Addendum 18 – Regulation No. 19

Revision 7 - Amendment 1

Supplement 6 to the 04 series of amendments – Date of entry into force: 9 October 2014

Uniform provisions concerning the approval of power-driven vehicle front fog lamps

"Figure 2 Light distribution of the Class B front fog lamp

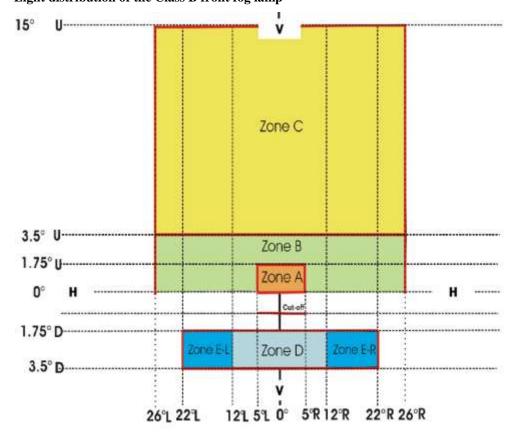
Annex 4,
Paragraph 2.1., Figure 2, amend to read:
